PROCUREMENT SERVICES ADDENDUM

Date of Notice:	3/12/2025
Solicitation No.:	RFP-020-25
Title:	Soccer Facility Graphics Update
Addendum No.:	One (1)

TEAM DINING

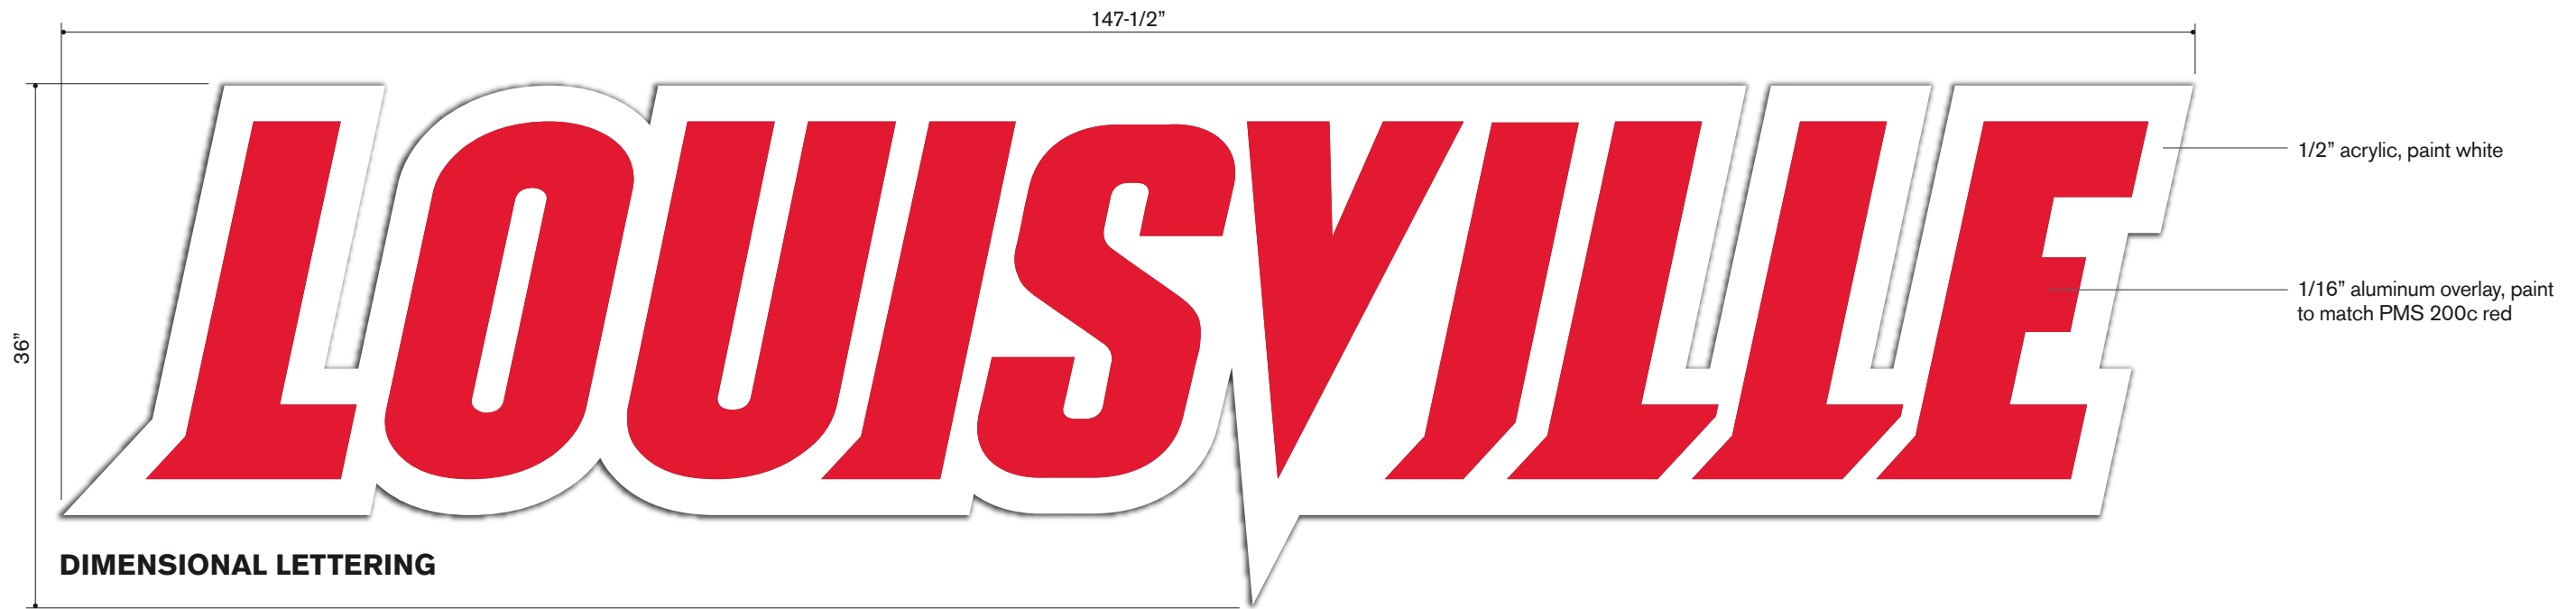
The updated graphics for the Team Dining Room and the Classroom are Attached hereto.
